Document type
Stage 2 Acoustic Report

Date
August 2022

25 TAVISTOCK PLACE

ACOUSTIC STAGE 2 REPORT

Project Title:		25 Tavistock Place	
Project No:		RUK202200331	
Sketch No:		First Floor	
Title:		Internal sound insulation requirements	
Scale:		Not to scale	
Eng:	Rev:	Date:	Checked:
MF	-	28/07/2022	ST

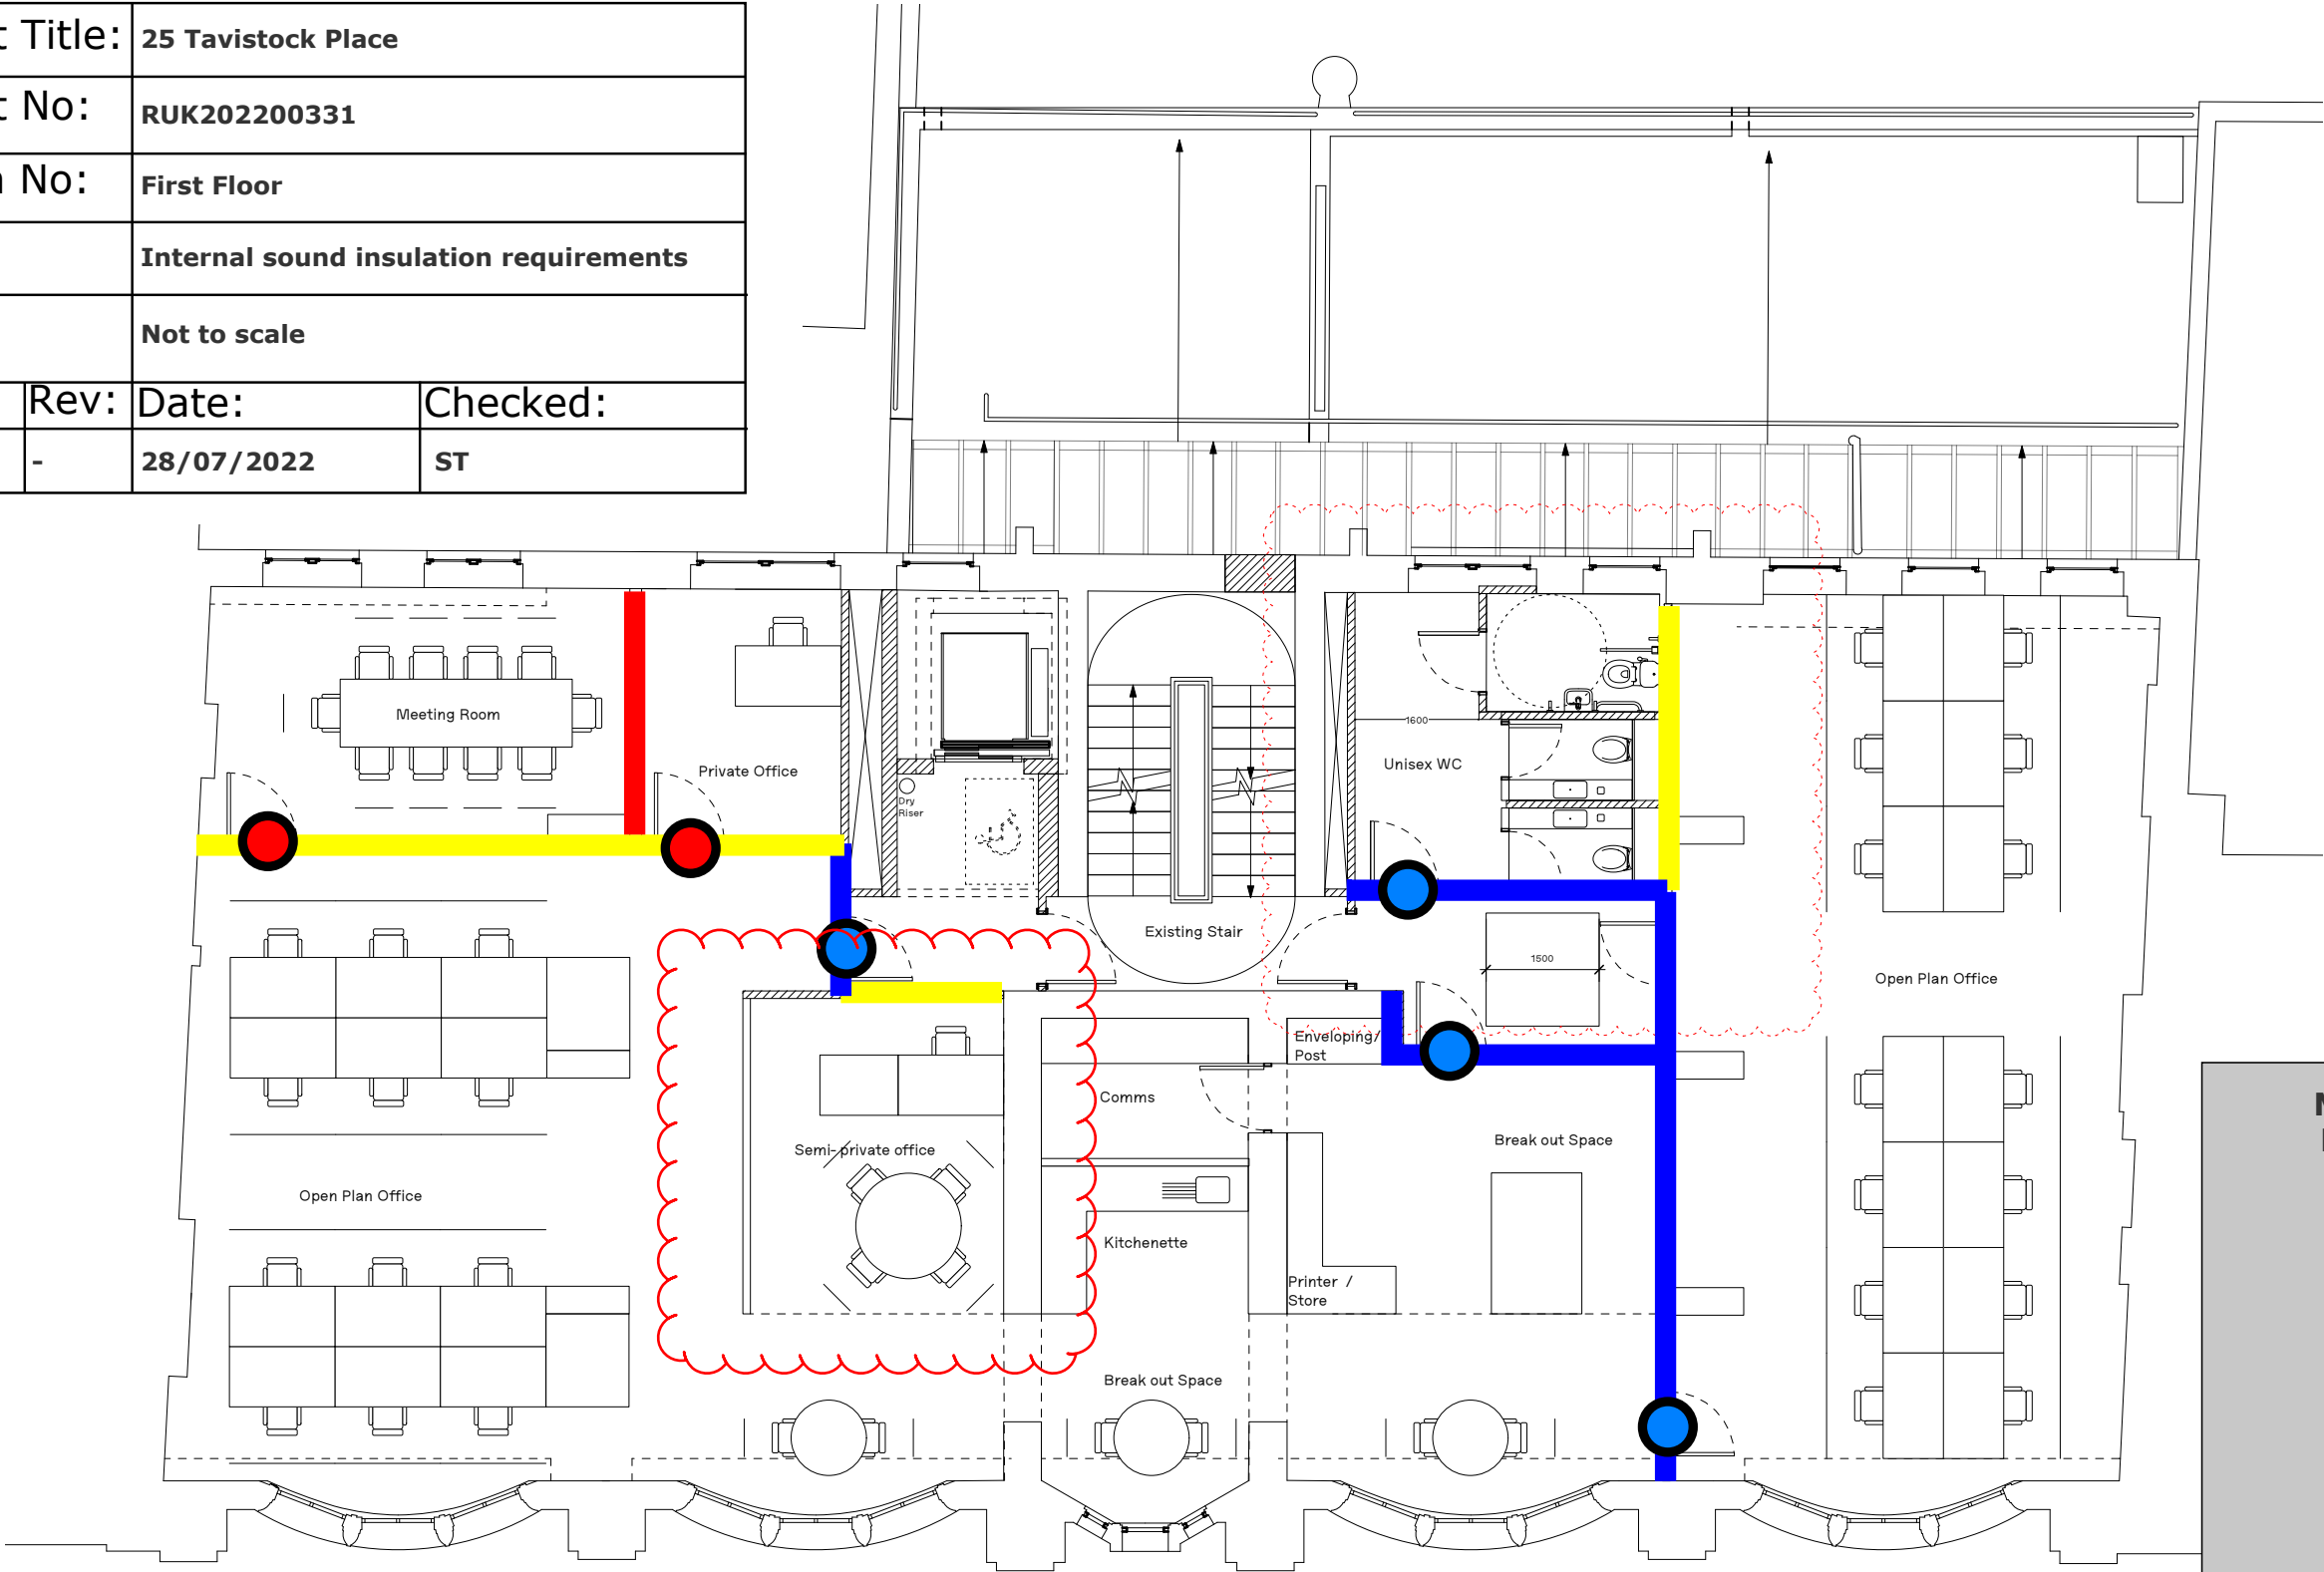
R_w 40 dB partition

R_w 45 dB partition

R_w 56 dB partition

R_w 30 dB doorset

R_w 35 dB doorset

Project Title:		25 Tavistock Place	
Project No:		RUK202200331	
Sketch No:		Second Floor	
Title:		Internal sound insulation requirements	
Scale:		Not to scale	
Eng:	Rev:	Date:	Checked:
MF	-	28/07/2022	ST

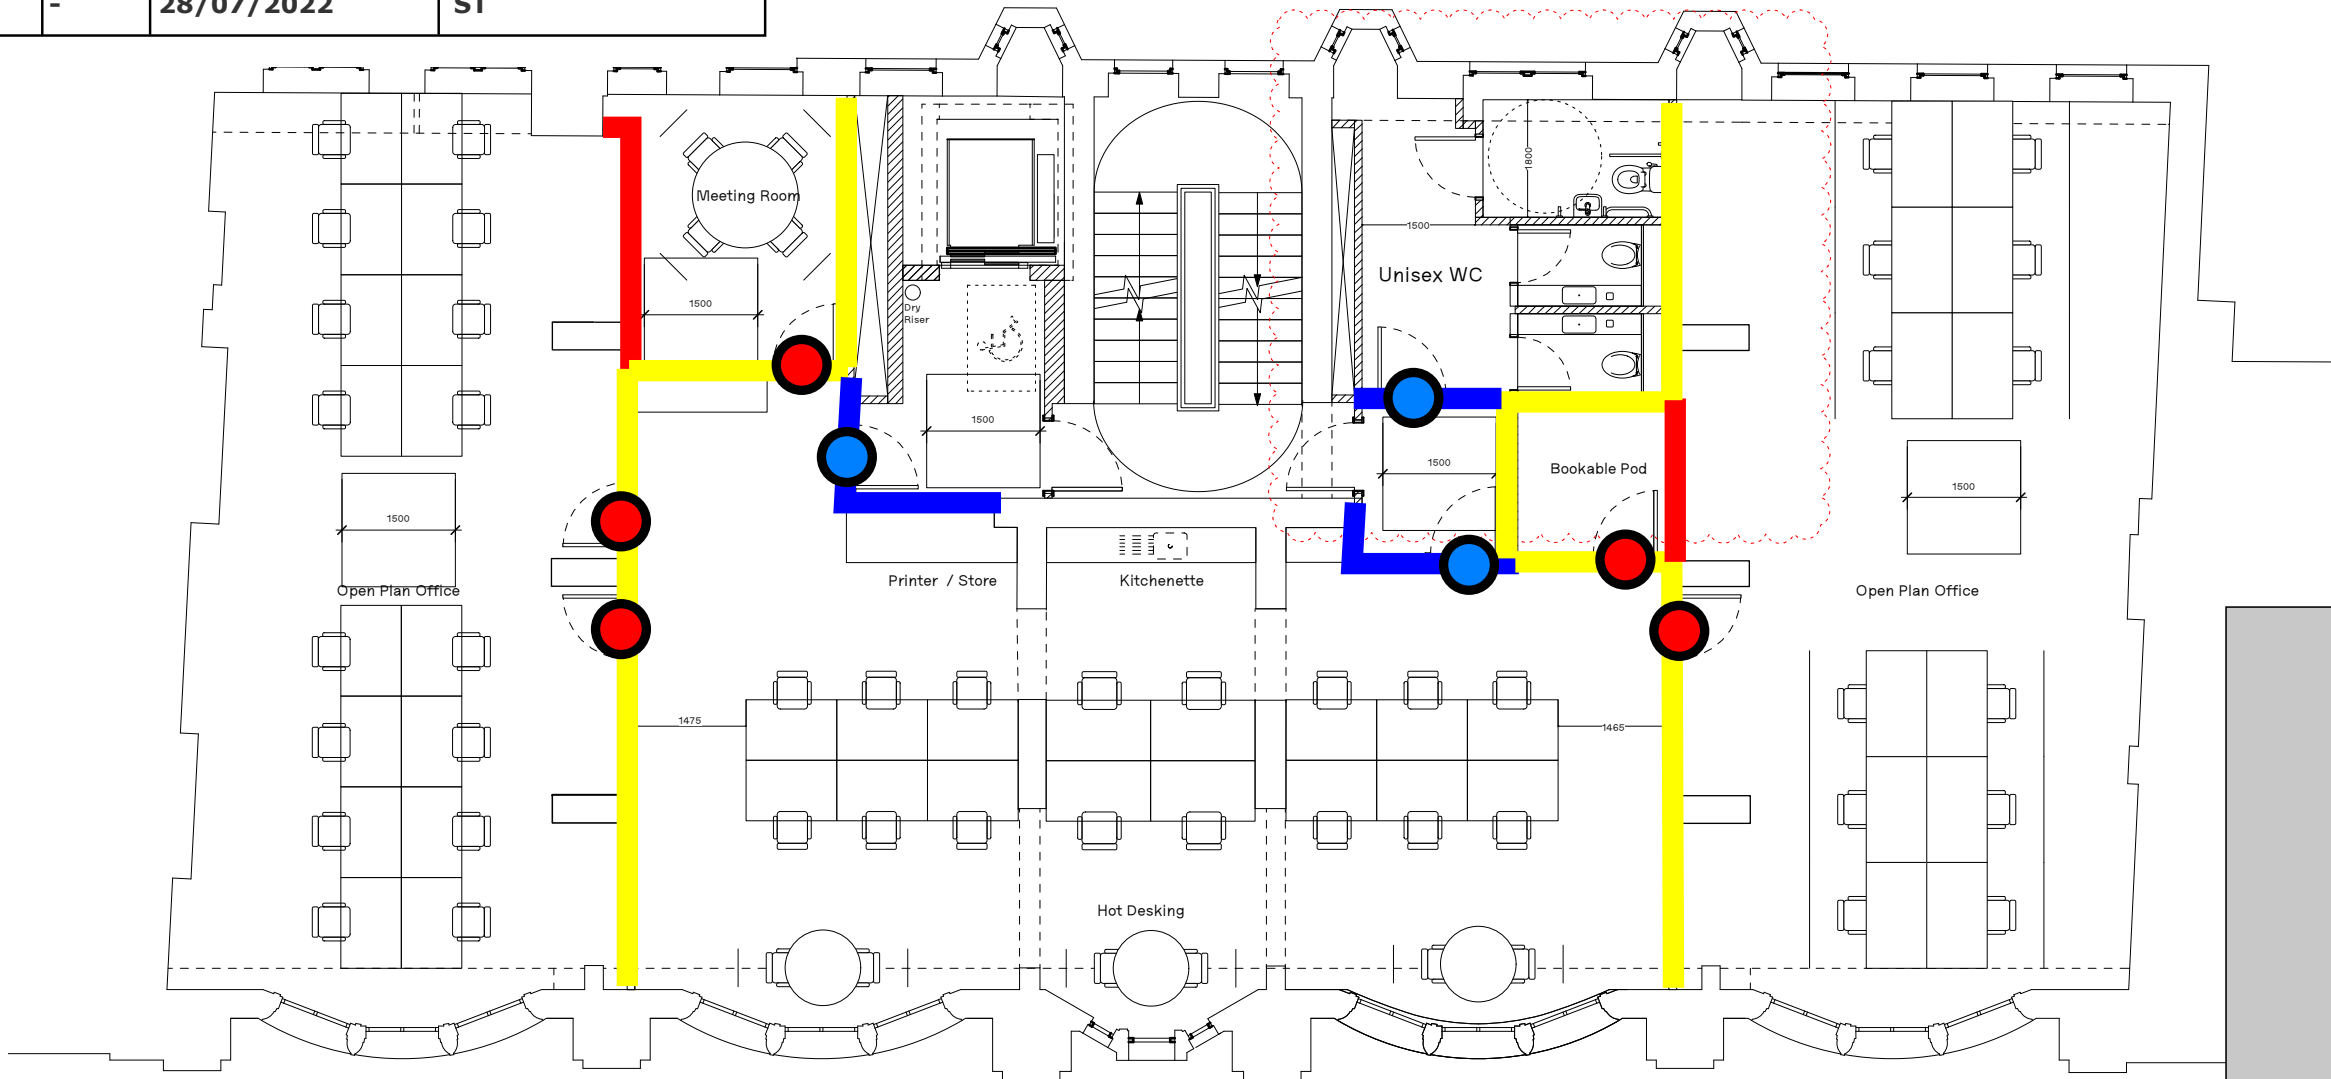
-  **R_w 40 dB partition**
-  **R_w 45 dB partition**
-  **R_w 56 dB partition**

-  **R_w 30 dB doorset**
-  **R_w 35 dB doorset**

Project Title:		25 Tavistock Place	
Project No:		RUK202200331	
Sketch No:		Third Floor	
Title:		Internal sound insulation requirements	
Scale:		Not to scale	
Eng:	Rev:	Date:	Checked:
MF	-	28/07/2022	ST

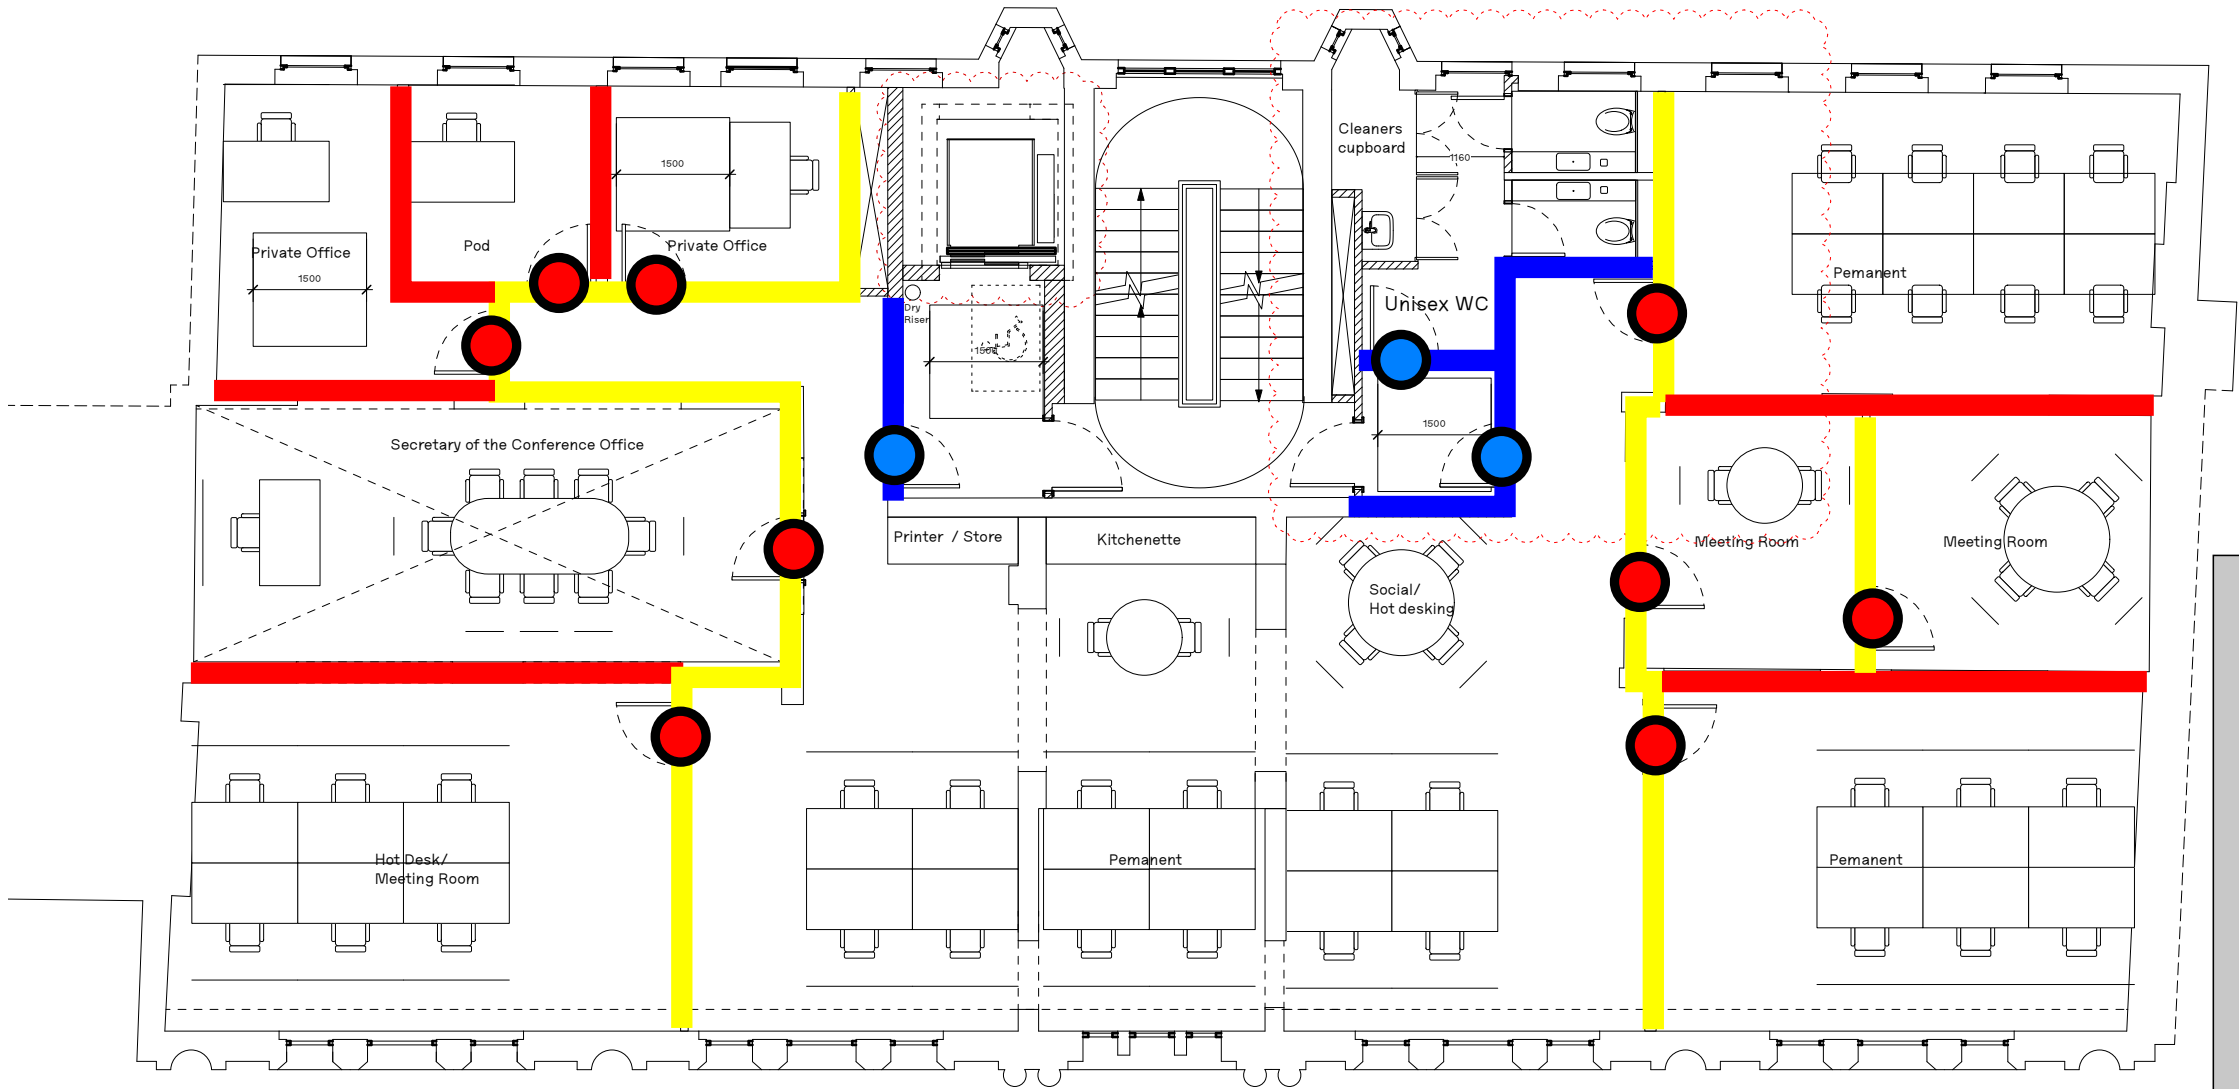
- **R_w 40 dB partition**
- **R_w 45 dB partition**
- **R_w 56 dB partition**

- **R_w 30 dB doorset**
- **R_w 35 dB doorset**
